REF: SUP25-0006
DATE: March 13, 2025

| Request | - | Special Use Permit for a Gas Station |
| Location | - | 1565 Alexis Road |

C1.0

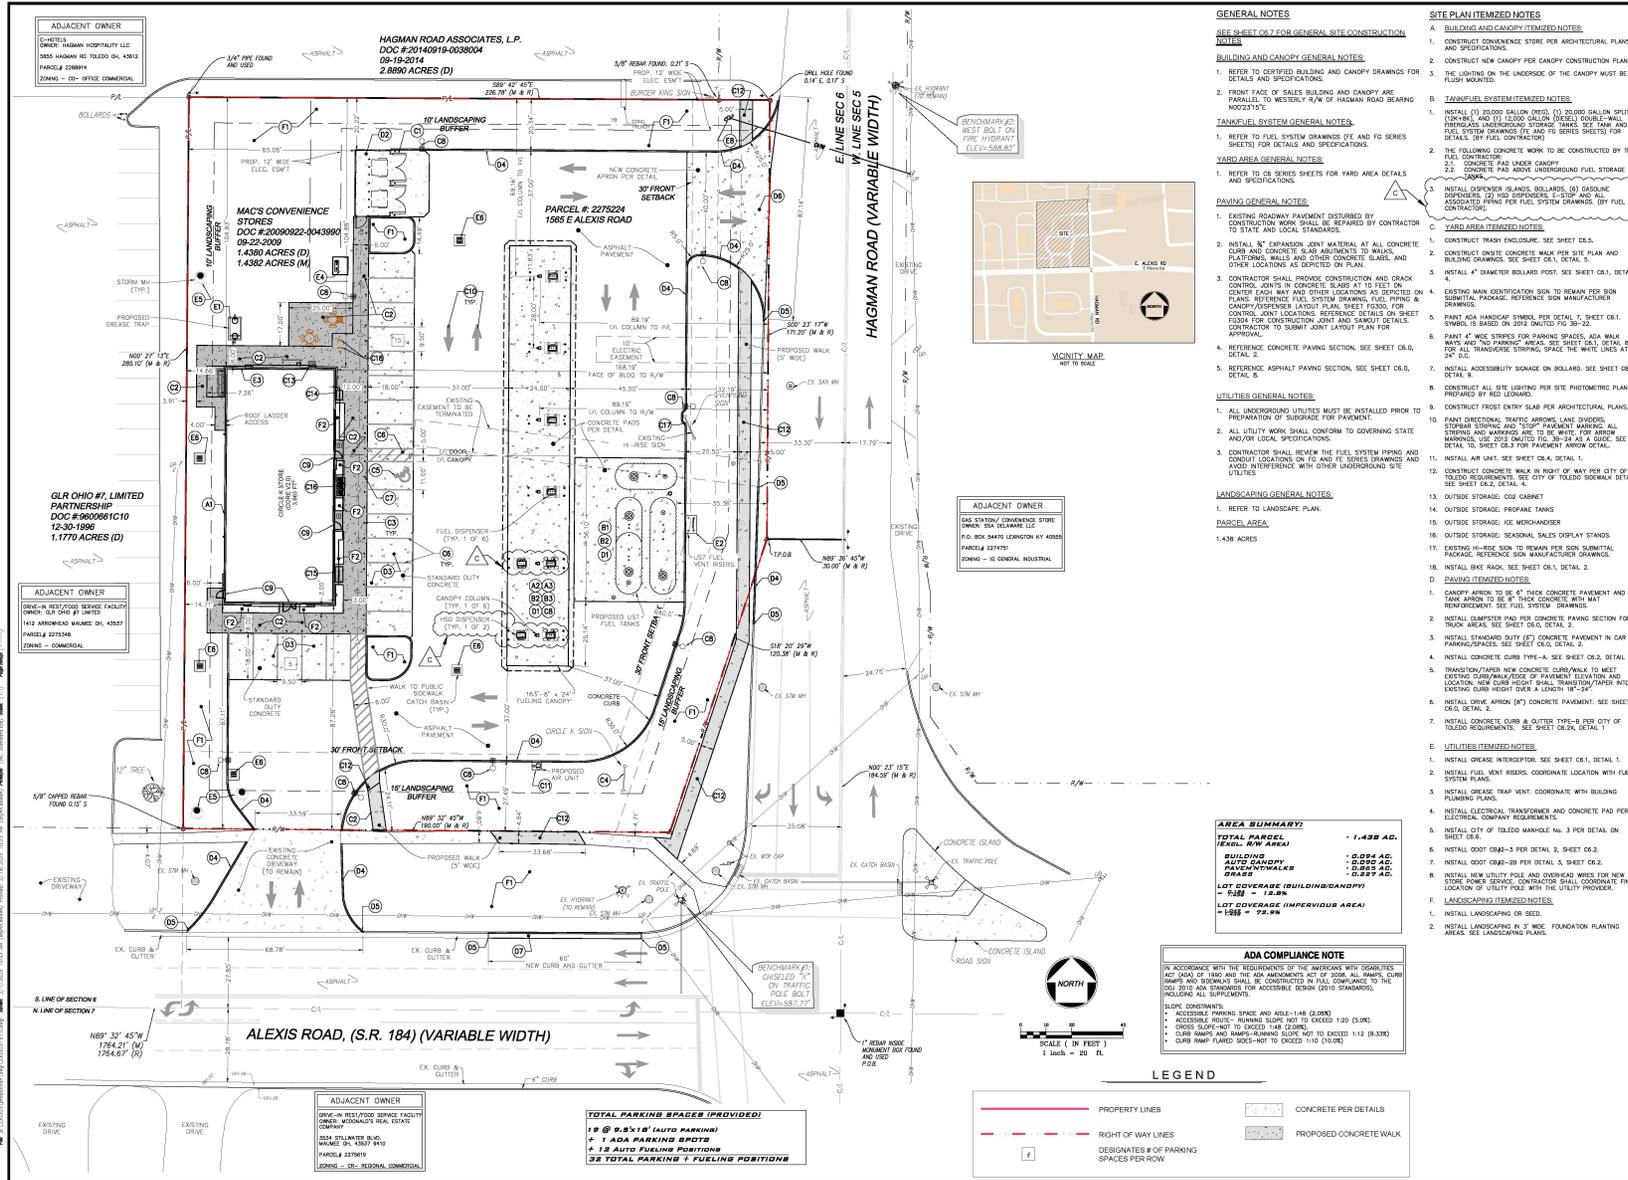
- a. The site plan meets the required minimum parking spaces (20 of 14 required), plus the 12 parking spaces at the pumps.
- b. Bicycle parking spaces are missing on the site plan. Per TMC§1107.0304, one space per 10 parking spaces shall be provided. This equates to four bicycle parking spaces. The Division of Transportation also set this condition.

- c. Per TMC §1109.0204(A) – Connecting Walkways, a pedestrian walkway from the right-of-way to the primary entrance is required. The walkway shown on the site plan goes from Alexis Road the principal building which faces Hagman Road. Given the site’s configuration, an alternative cannot be determined without significant changes to the site plan.

17. Bicycle parking is required per TMC§1107.0900.
18. Accessible parking signage must be posted directly in front of the parking spaces at a height of no less than 60 inches and no more than 72 inches above pavement level per TMC§1107.1704.

- INSTALL BIKE RACK, SEE SHEET C01.0, DETAIL 2.
